BID ADDENDUM NO.1

2181539 Bank on Buffalo, Niagara Falls, NY

There was an error during the printing process that caused the structural & HVAC items to not appear in the Architectural drawings. Some of the drawings being replaced are only to show the missing items for clarification. No actual changes are occurring on these sheets. Any changes to the drawings are clouded & tagged.

A502

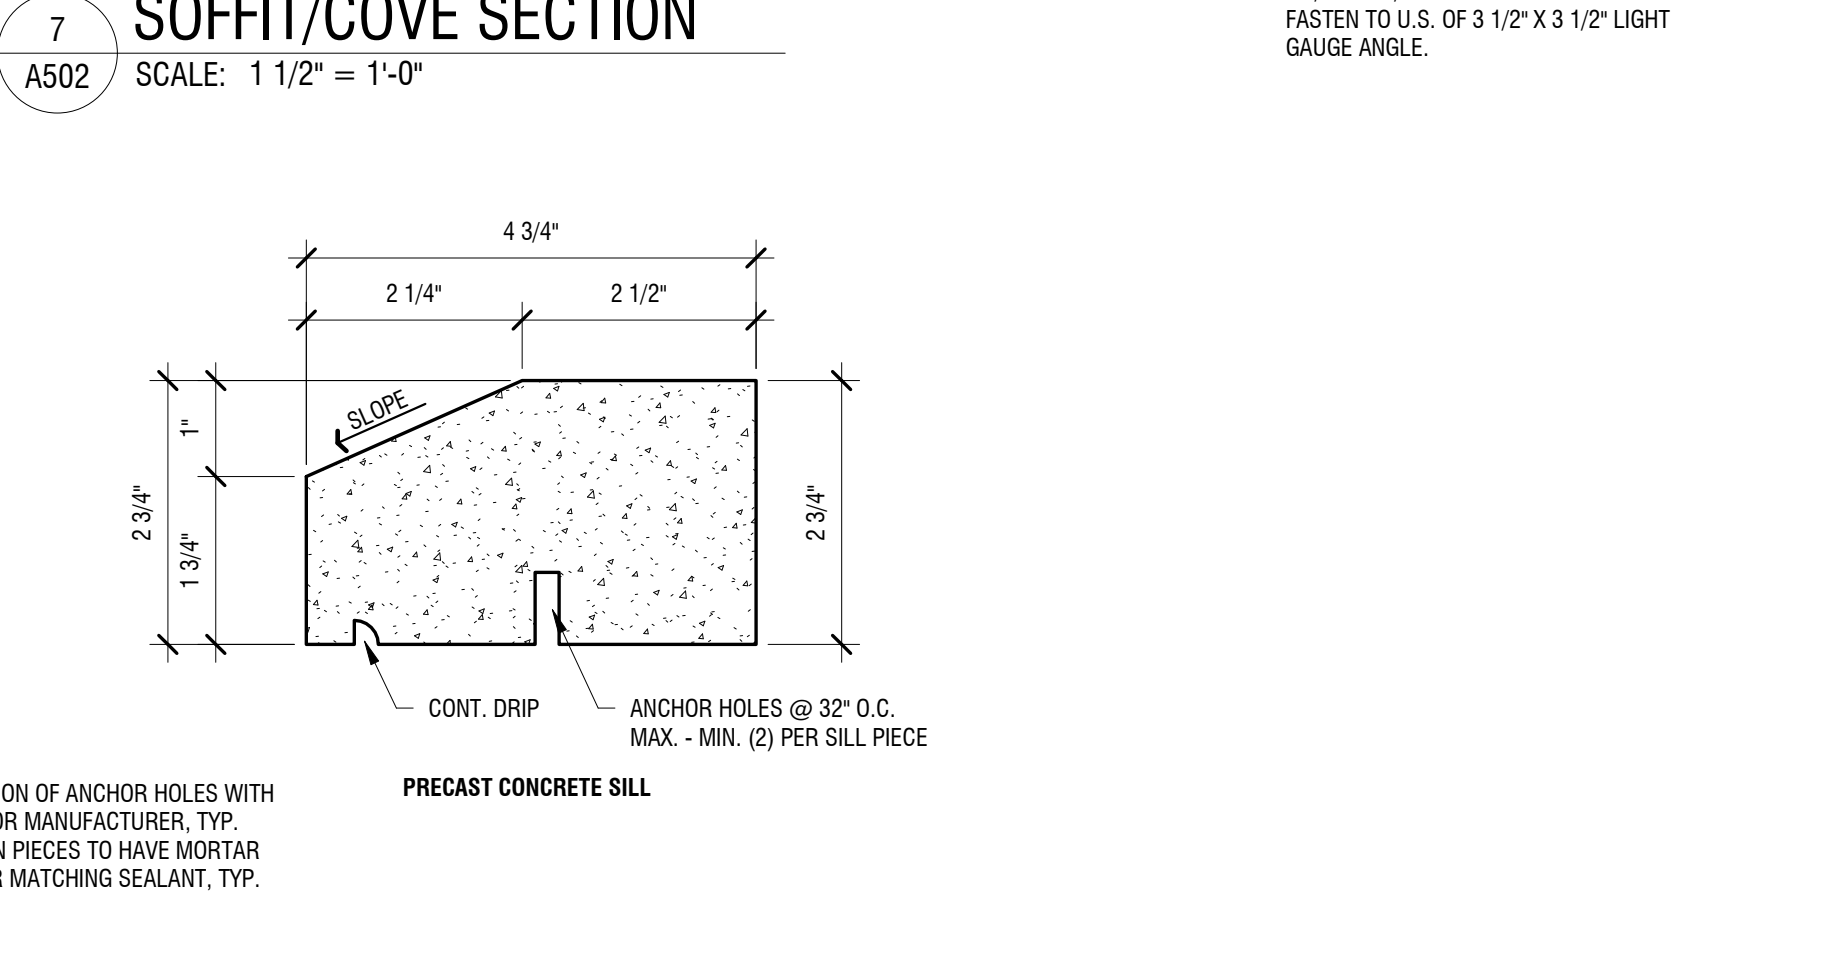
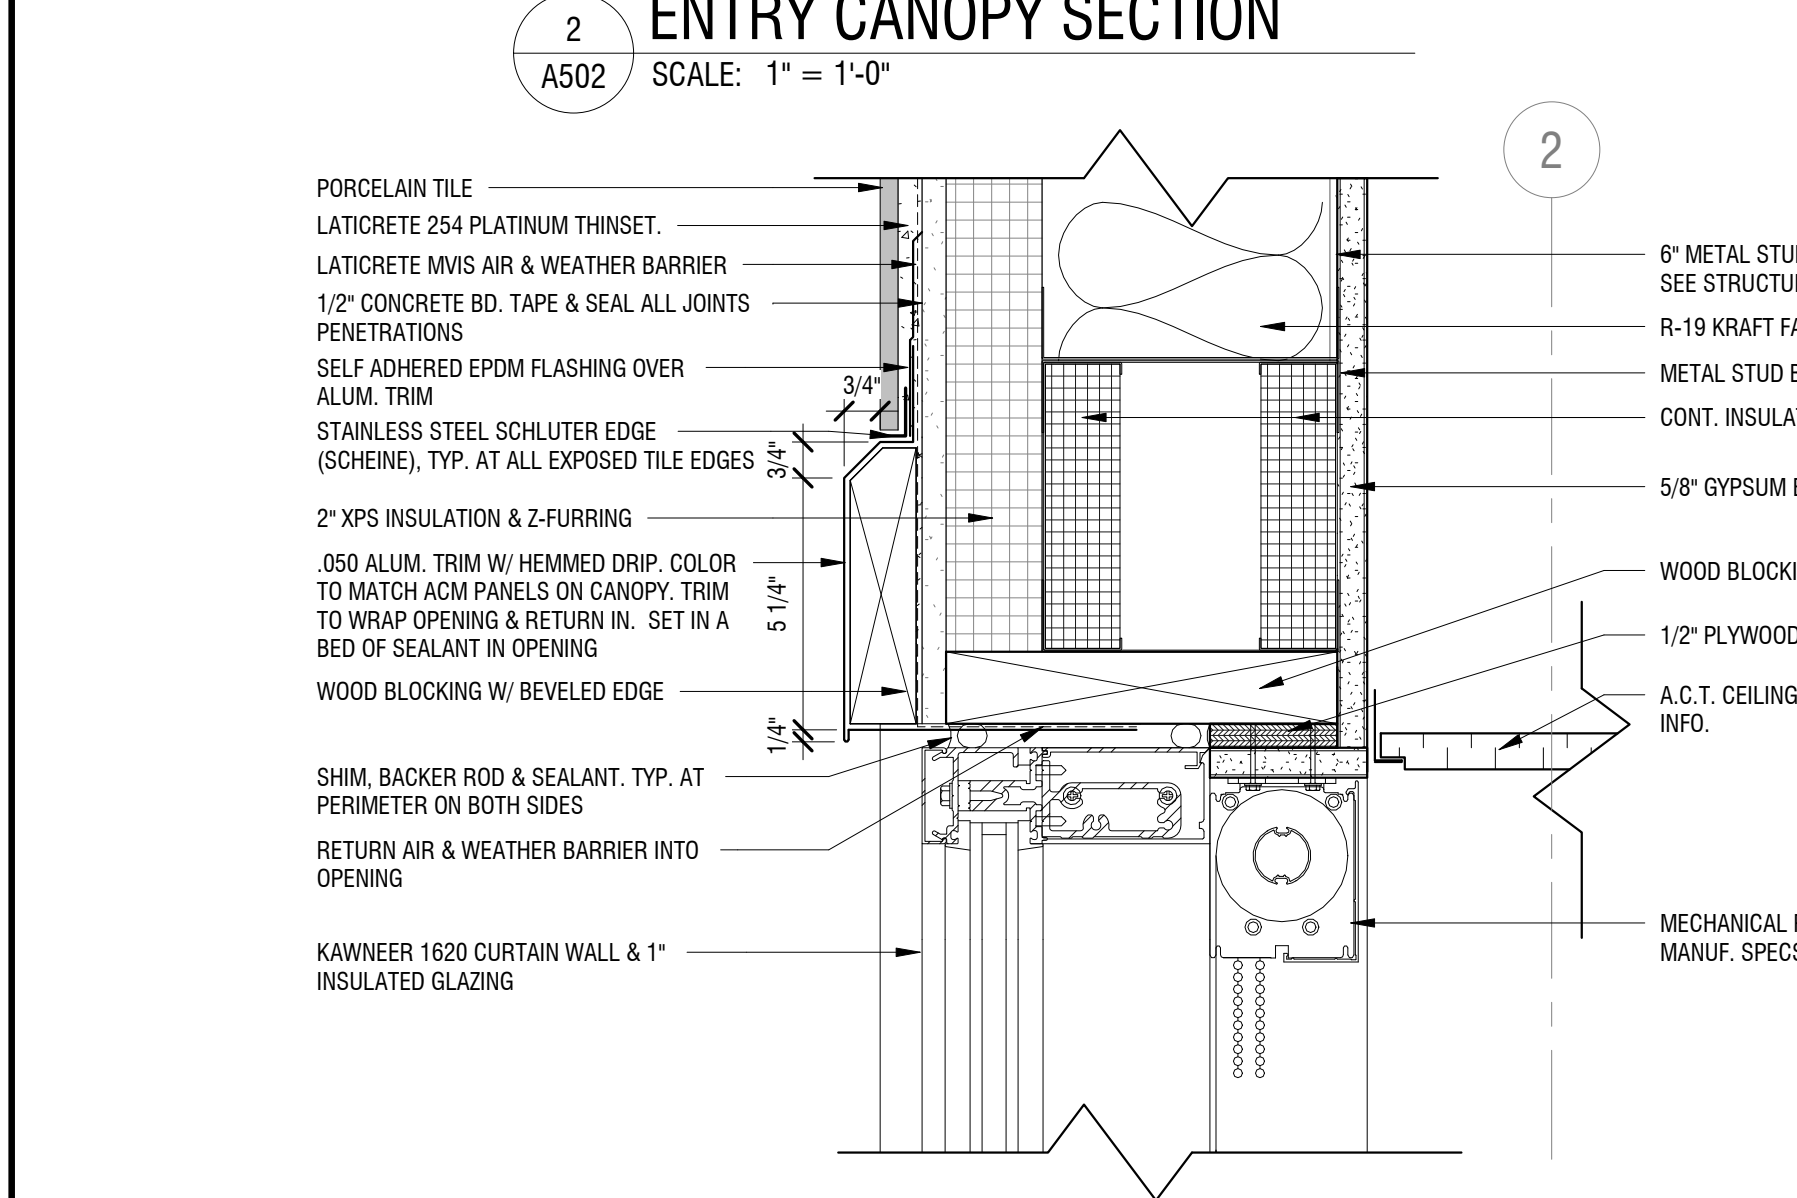
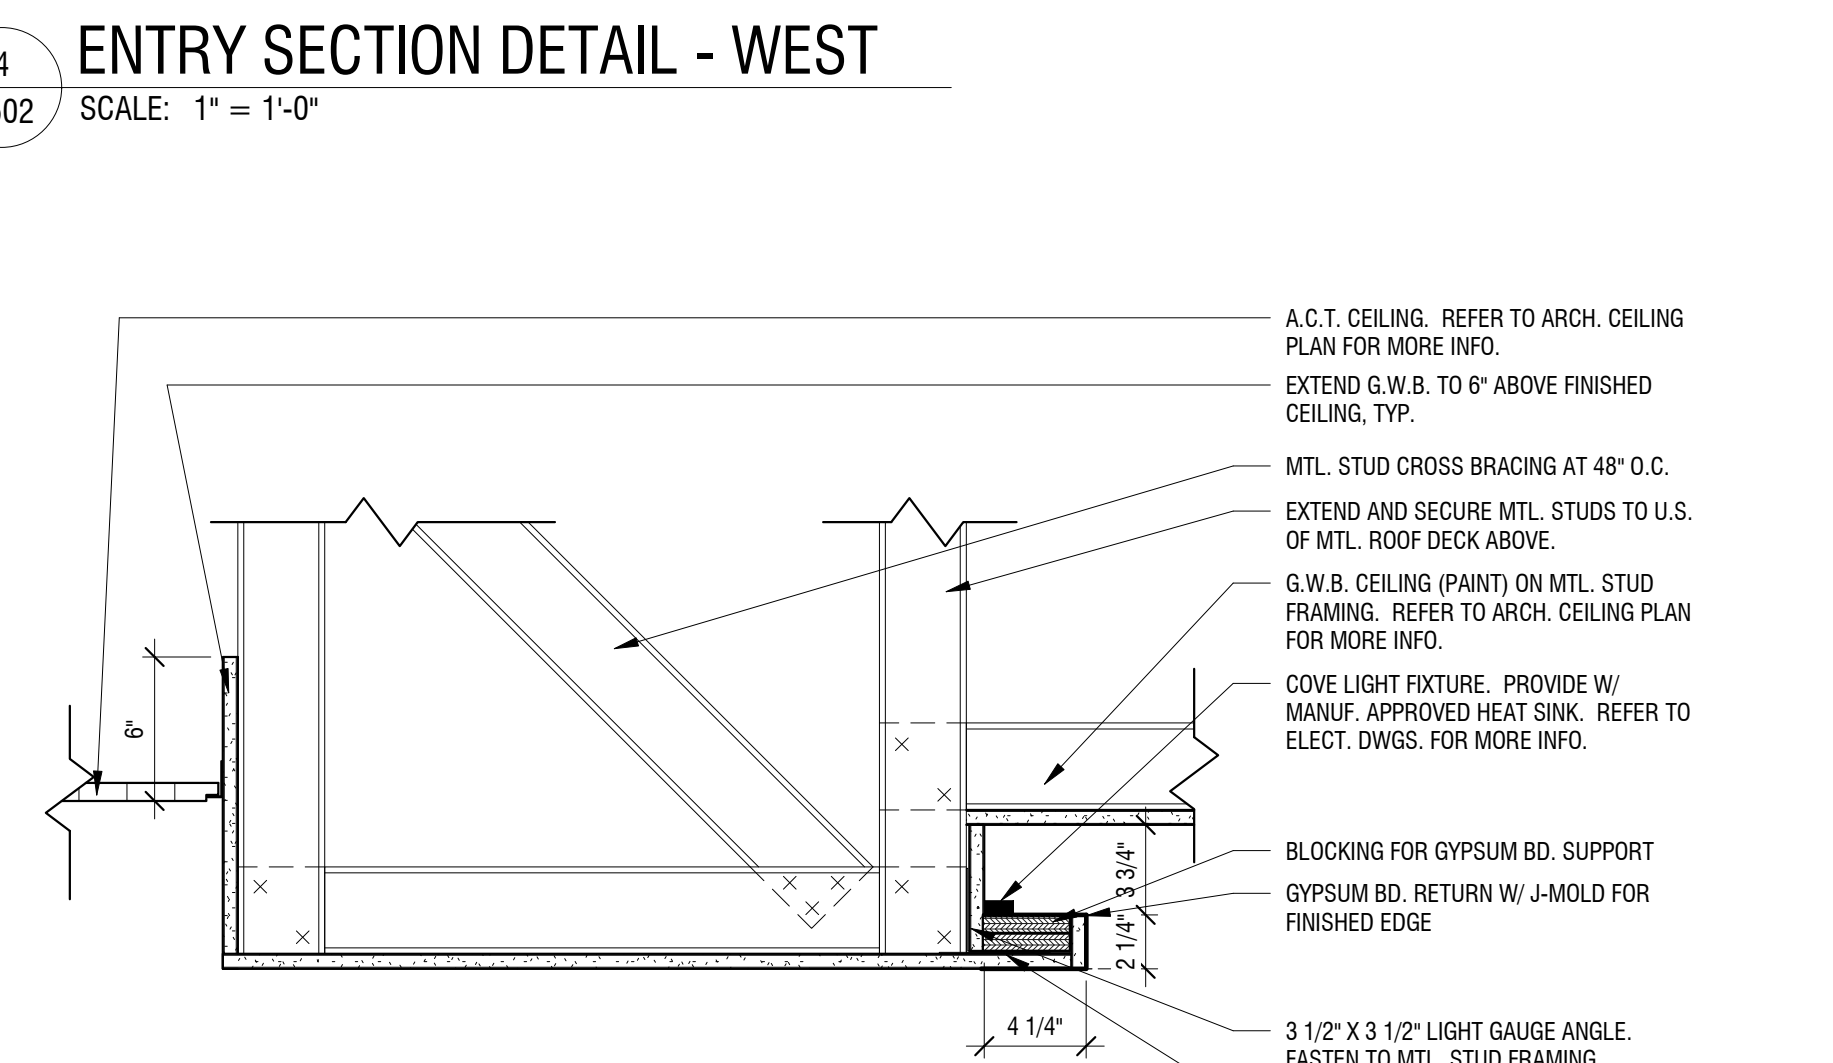
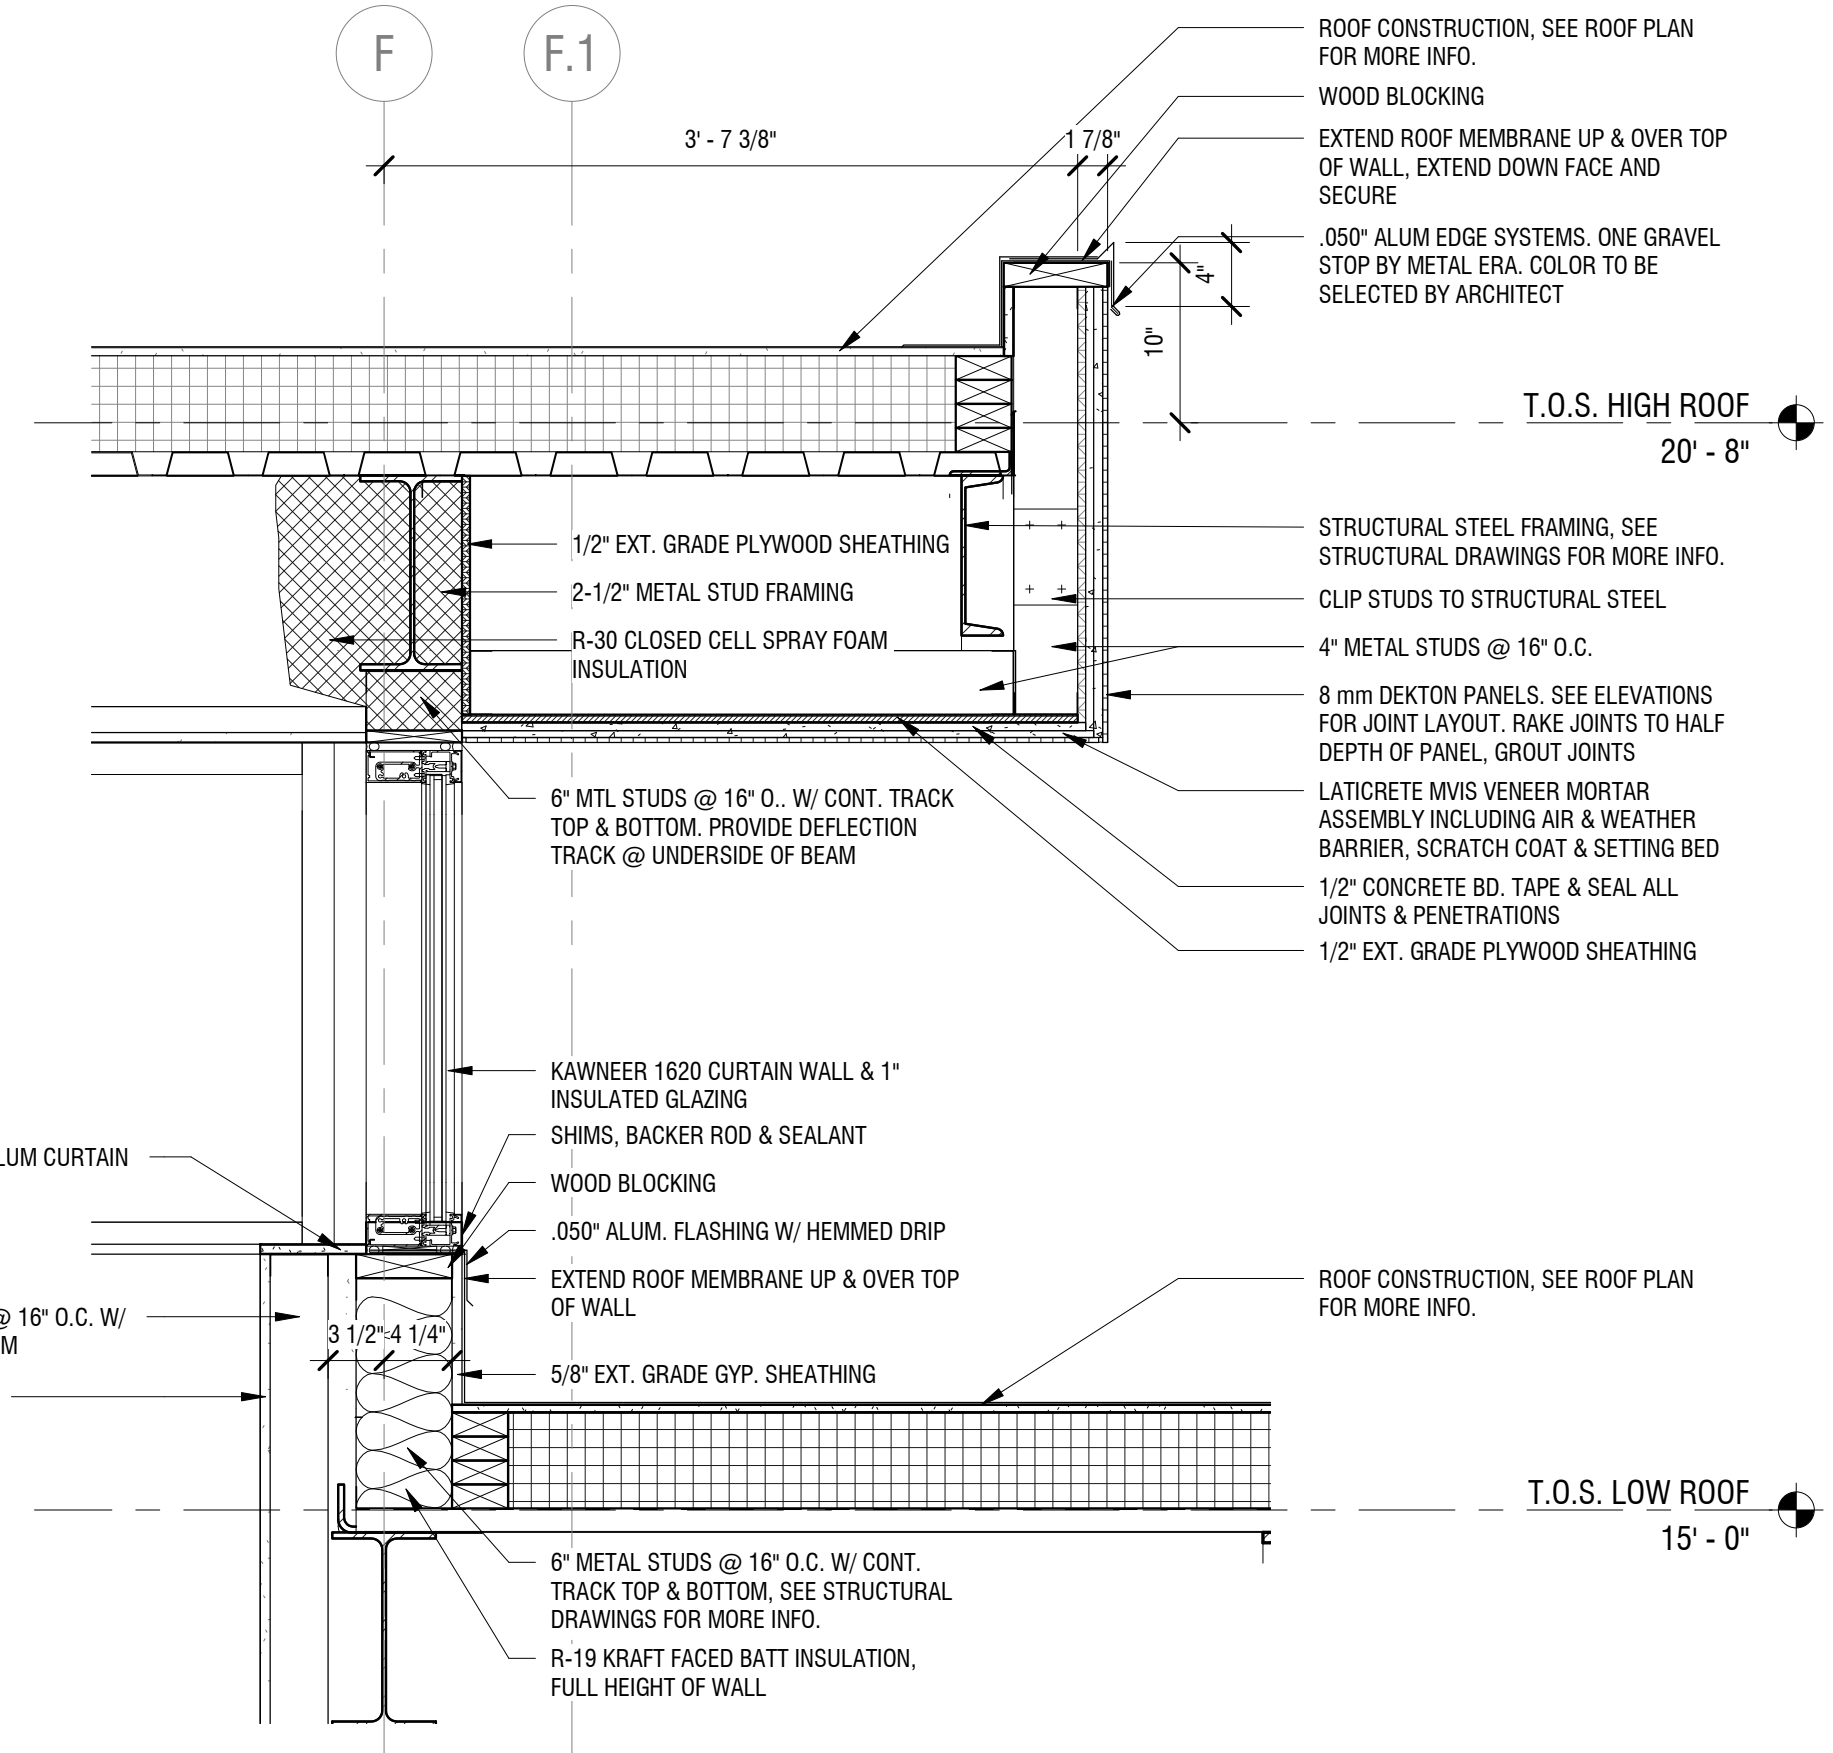
- N. Drawing A502**
 - 1. DELETE Drawing in its entirety
 - 2. ADD replacement Drawing A502
 - 3. Structural items are now shown on drawings.
